EX1020
Petitioner Ascentcare ('686 Patent)
Solmetex Ex. 2026
Ascentcare Dental Products v. Solmetex - IPR2025-01175

Serial No.: 14/228,057 | Filed: March 27, 2014

Title: INTRAORAL DEVICE WITH SLIT

FIG. 1B

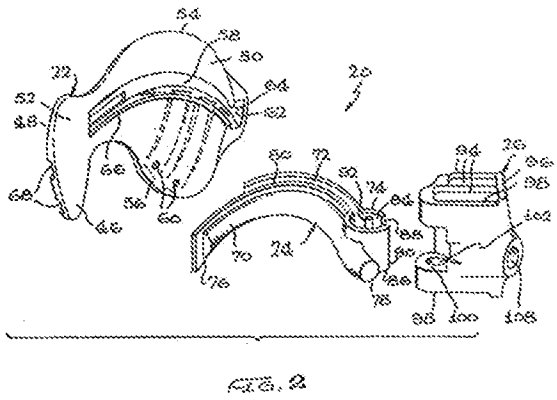
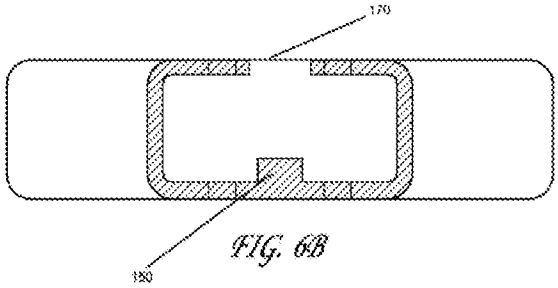
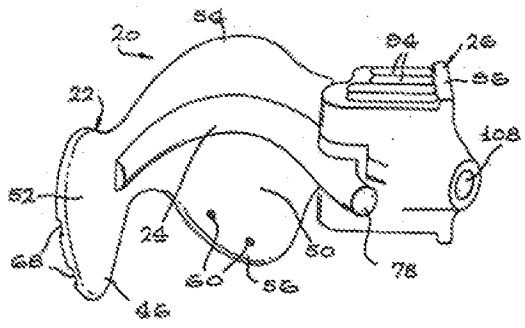
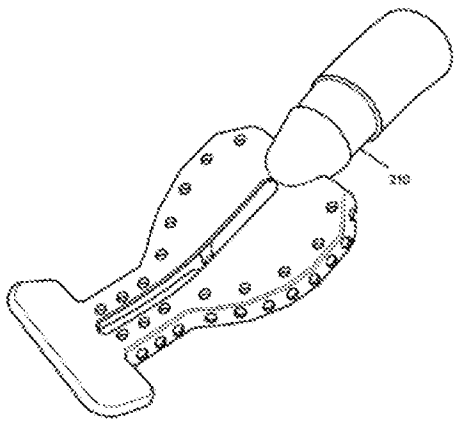
As illustrated in the figures provided above, the claimed slit comprising an opening which allows fluids exterior to the pocket to enter into the interior open space of the pocket along the longitudinal and central axis. FIG. 1B is a top view of the mouthpiece, with reference to the slit as element 170 and FIG. 6B is a cross-sectional view of the mouthpiece. As shown in FIG. 6B, the slit opens into the interior open space of the pocket, allowing fluids to freely enter and flow into the open space which extends at least the length of the slit. *Hirsch* fails to disclose such open space or slit.

Hirsch does not disclose a slit extending along a longitudinal and central axis of the main body portion between opposite ends of the main body portion and the slit comprising an opening that allows fluids exterior to the pocket to enter into the interior open space of the pocket along the longitudinal and central axis. The *Office Action* points to *Hirsch's* component "66" as a slit and points to FIG. 2, shown below, and paragraph 51 as describing a slit 66 that allows fluids exterior to the pocket to enter into the interior of the pocket. *Office Action*, 3. *Hirsch* explicitly refers to the component "66," however, as a "pair of shallow evacuation channels 66," shown below. *Hirsch* para. [0051].

Patent 3,768,477	Current Application

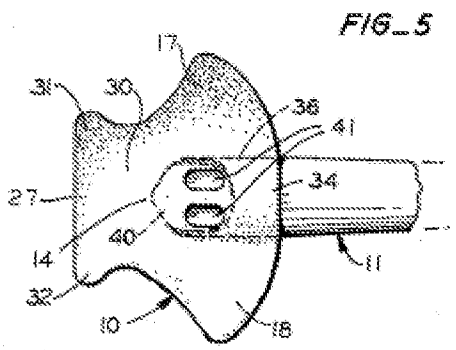
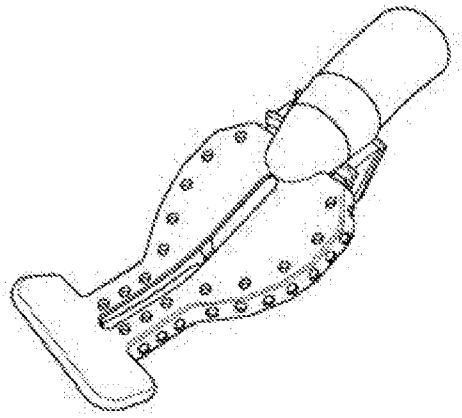
The Applicant disagrees with the Examiner's characterization that one of the apertures 30 is equivalent to a slit extending along a longitudinal and central axis of a main body. Merriam-Webster defines a slit as "a long narrow cut or opening."[1] The apertures 30 shown above and by definition are neither a long narrow cut nor a long narrow opening. However, to expedite prosecution, claim 1 has been amended to include "a slit extending **parallel to a longitudinal and central axis** of the main body." None of the apertures 30 shown or described extend parallel to a longitudinal and central axis of a main body portion. As such, *Anders* does not teach "a main body comprising a wider end portion opposite a narrower end portion" and "a slit extending parallel to a longitudinal and central axis of the main body through the wider end portion, and through the narrower end portion of the main body."

FIG. 1B

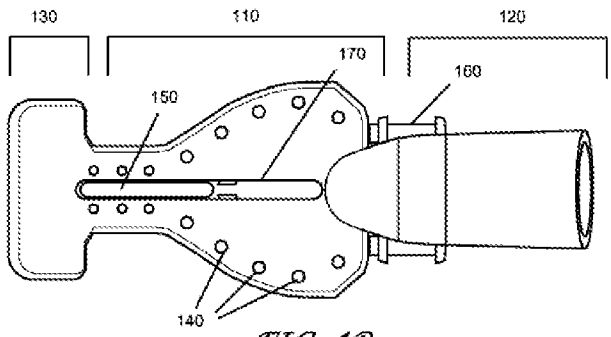
The recited limitations find support in the *Specification*, which describes "a longitudinal open slit 170" "extending over approximately two-thirds of the main body on the anterior surface" that "fac[es] the front of the mouth." *Specification*, [0033], [0039]. The slit 170 runs "along the center of the main body across the rectangle and the most of the arrowhead" to "assist in capture and suction of water, saliva and debris, as well as assisting in cleaning and maintenance" as seen below in FIG. 1B. *Id*. at [0039], FIG. 1B.

ANDERS	HIRSCH
	 FIG. 2

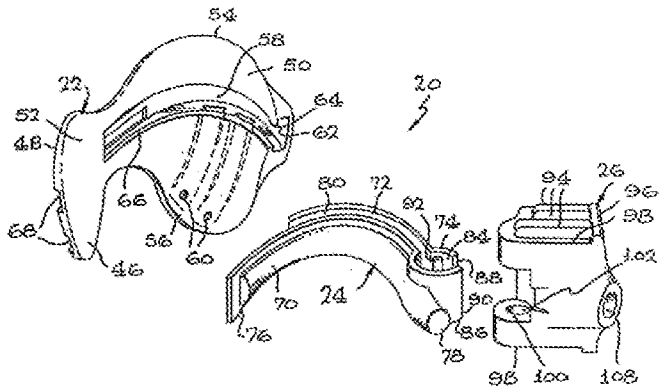
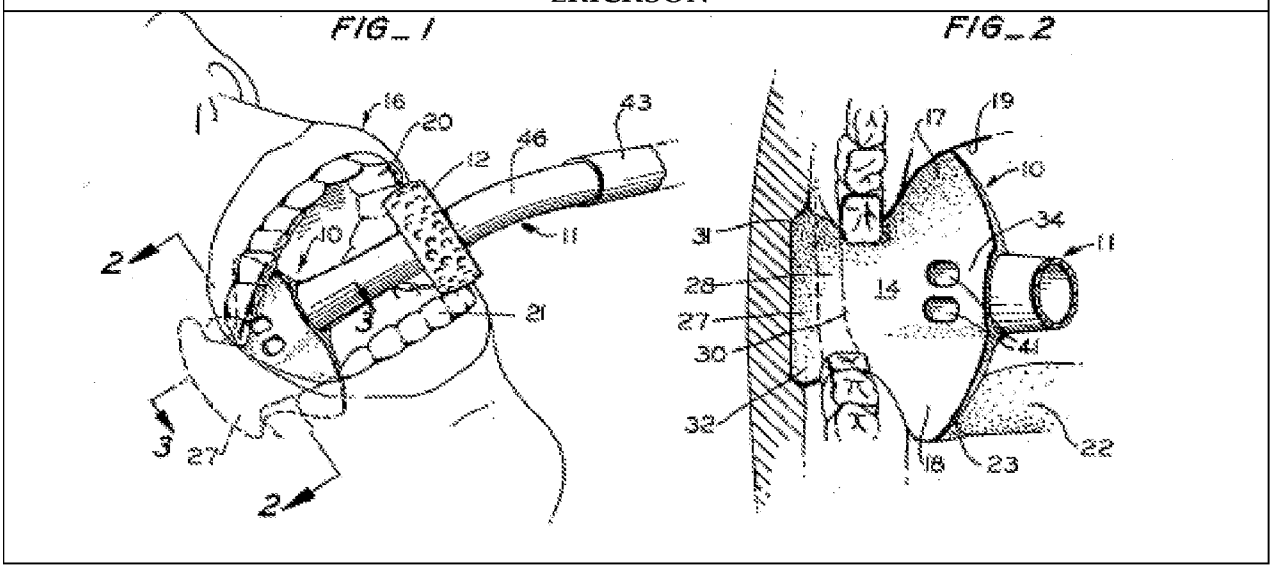
The *Office Action* argues that "the aperture 30" of *Anders* is "equivalent to the claimed slit extending along a longitudinal and central axis of the main body portion between opposite ends of the main body portion" "by broadest reasonable interpretation of the claimed 'slit' being a "cut" or "an opening."" *Office Action* at 3.

Anders discloses a "plurality of apertures" that are "grouped more toward the center of the depressor portion," which is not the same as a singular 'slit opening extending a longitudinal length parallel to a longitudinal and central axis of the main body' as claimed. *Anders*, col. 2, l. 59-60, FIG. 4. Moreover, the apertures of *Anders*, single or in a group, do not extend 'a

Hirsch does not cure the deficiency of *Anders*, as *Hirsch* fails to disclose any 'slit opening extending a longitudinal length.' Although the *Office Action* argues that element 58 of *Hirsch* discloses a slit, element 58 of *Hirsch* is actually an "internal evacuation channels 58" that is covered by "a flange 76" and "dispersion piece 24" as seen in FIG. 2. *Office Action* at 3; *Hirsch*, [0051], [0053], [0054], FIG. 2. Instead, *Hirsch* discloses "evacuation holes 66" and "evacuation hole 60" that "allow communication of the evacuation channels 58 with the other surface 48 of the retractor 22." *Hirsch*, [0051], FIG. 2. Thus, the "internal evacuation channels 58" of *Hirsch* does not disclose 'a slit opening' that 'allow[s] fluids exterior to the pocket to enter along the longitudinal length into the interior open space of the pocket' as claimed. *Id.*

FIG. 19B

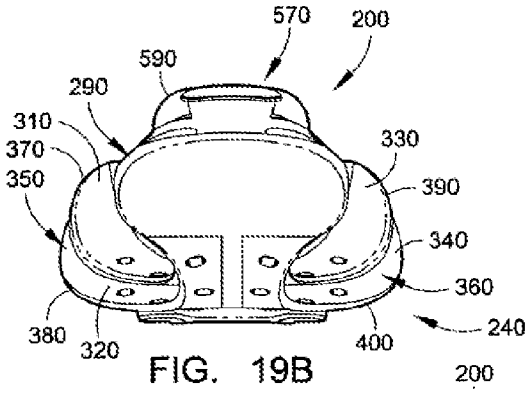
Hirsch similarly fails to disclose the claimed 'bridge structure.' *Hirsch* only discusses "the flaps 320, 33, 340, 350" that "all extend from and share a common, central spine 365" as illustrated in FIG. 19B below. *Hirsch*, [0082], FIG. 19B. Such "central spine 365" of *Hirsch* "extends longitudinally a majority of the length of the retractor 240 and divides the upper half 210 from the lower half 220 of the intraoral device 200," to attach "upper front flap 310," "upper rear flap 320," "lower front flap 330," and "lower rear flap 340." *Id.* In contrast, the claim recites that the 'bridge structure' only protrudes from 'an interior surface of the second wall' and 'not attached to the first wall.' Moreover, *Hirsch* fails to disclose any 'wave shape' protrusion 'protruding from an interior surface of the second wall,' that comprise 'one or more crests and one more troughs' as claimed.

Thus, *Anders* and *Hirsch*– individually or in combination – fail to teach '**a bridge structure** that includes **a plurality of protrusions integral with and protruding from an interior surface of the main body**, the bridge structure extending a distance between the first wall and the second wall, wherein the protrusions of the bridge structure protrude in **a wave shape** comprising **one or more crests and one or more troughs**' as claimed.

FIG. 1E

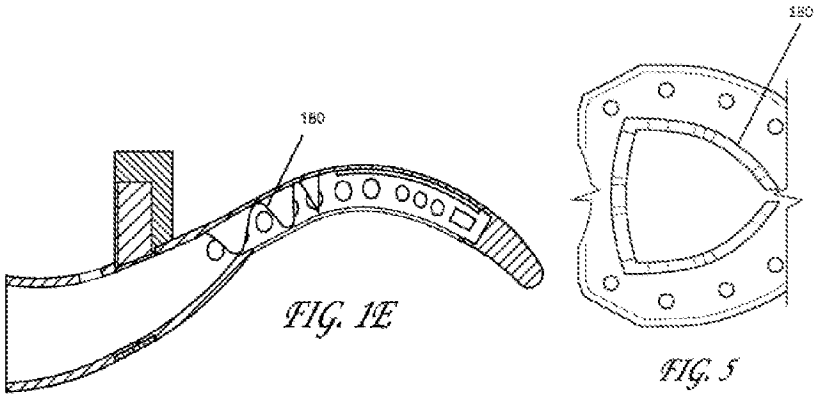
addition, FIGs. 1E and 5 (provided below) illustrate views of such a 'bridge structure' as follows:

FIG. 24C

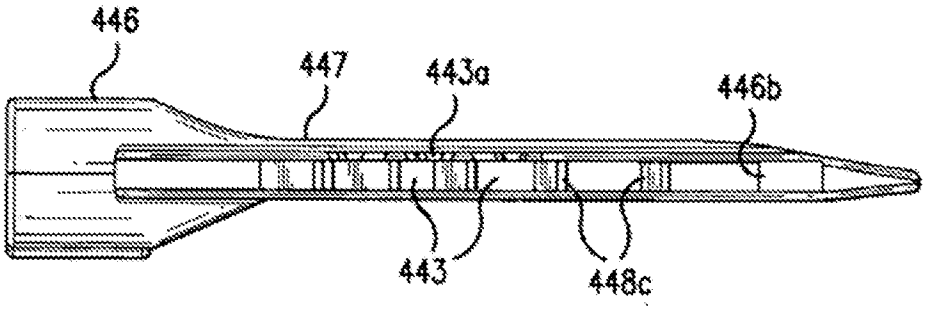
The *Office Action* argues that element 448c of *Black* teaches the claimed 'bridge structure.' *See Office Action* at 4. *Black*, however, discusses that "the proximal flap 440 *a* and/or the distal flap 440 *b* of the tongue shield aspirator 440 may be formed from a first (posterior) layer 448 *a* and a second (anterior) layer 448 *b* which are connected to, but spaced apart from, one another by walls 448 *c*." *Black*, {0130}. As shown in FIG. 24C below, *Black* teaches that a first layer and a second layer are connected to the wall 448c. Thus, *Black* cannot teach 'wherein the bridge structure is not attached the first wall' as claimed.

Moreover, the walls 448c of *Black* are rectangular columns and do not 'protrude in a wave shape comprising one or more crests and one or more troughs' that protrude from 'an interior surface of the second wall' as claimed. Thus, *Black* cannot teach 'wherein the protrusions of the bridge
